**TENNESSEE VALLEY AUTHORITY  
SEQUOYAH NUCLEAR PLANT  
UNITS 1 AND 2**

**ANP-3053(NP), Revision 3, Sequoyah HTP Fuel Transition –  
NRC RAIs and Responses, May 2012  
(Non-Proprietary Version)**

Sequoyah HTP Fuel Transition –  
NRC RAIs and Responses

AREVA NP Inc.

**Figure 4: Updated Core Safety Limit Lines for Sequoyah Technical Specifications**

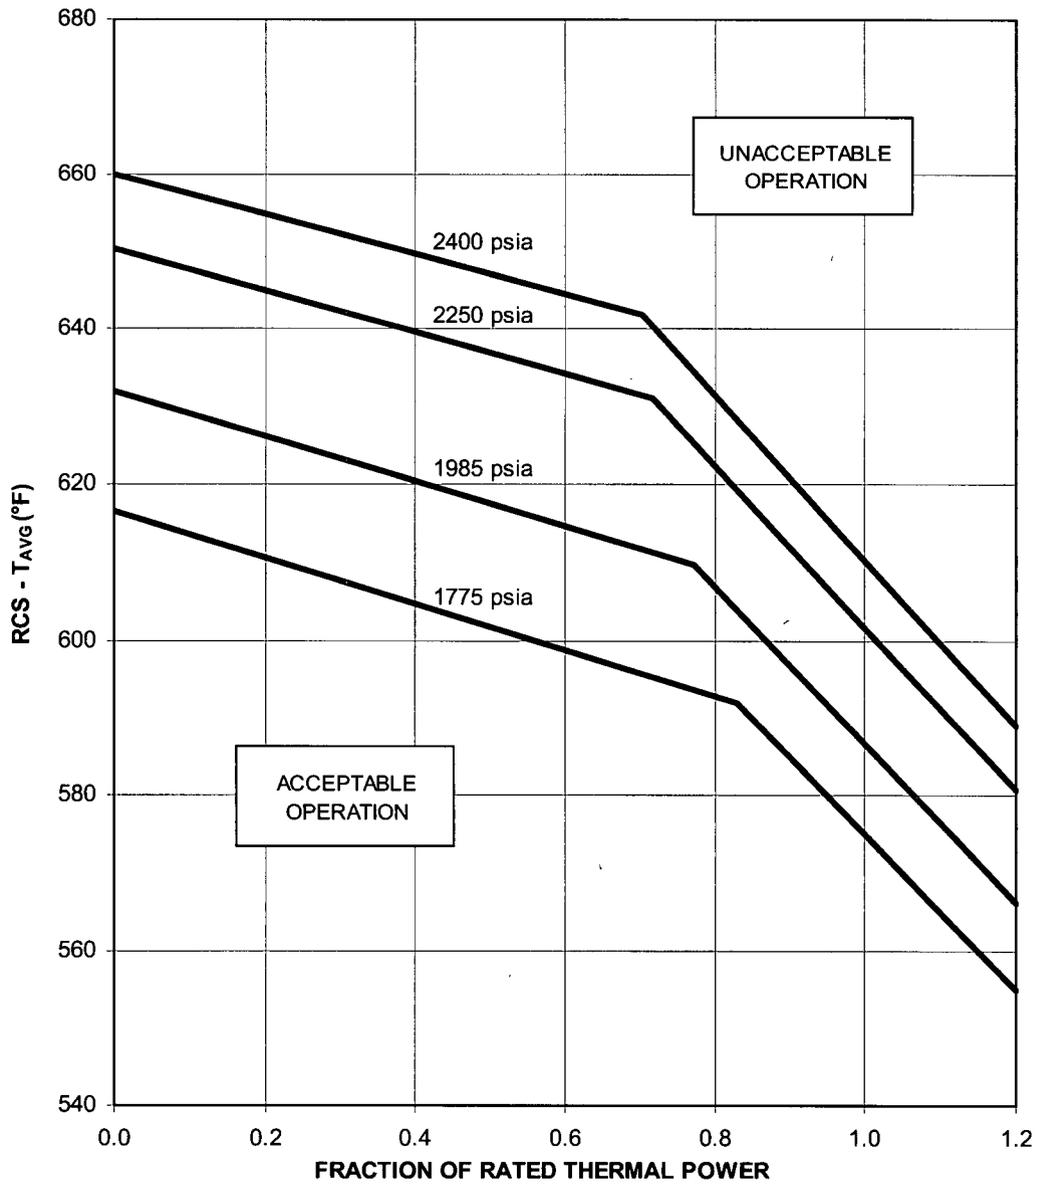
Provide a detailed description with respect to the applicability of all the approved methodologies listed in the proposed TS 6.9.1.14.a to the AREVA Advanced W17 HTP fuel design.

As a result of these changes, the core safety limit lines shown in Figure 2.1-1 of the SQN Units 1 and 2 Technical Specifications will be modified to represent the protected OT $\Delta$ T trip limit lines and are shown in Figure 4 below.

The revised CSL lines generated for the Adv. W17 HTP fuel design at the higher reactor coolant flow rate were evaluated against the Mark-BW CSL lines at the current reactor coolant flow rate, and it was shown that the CSL lines shown in Figure 4 are applicable to both fuel designs resident in the SQN Units 1 and 2 cores. Therefore, Figure 4 is applicable for use in the SQN Units 1 and 2 Technical Specifications.
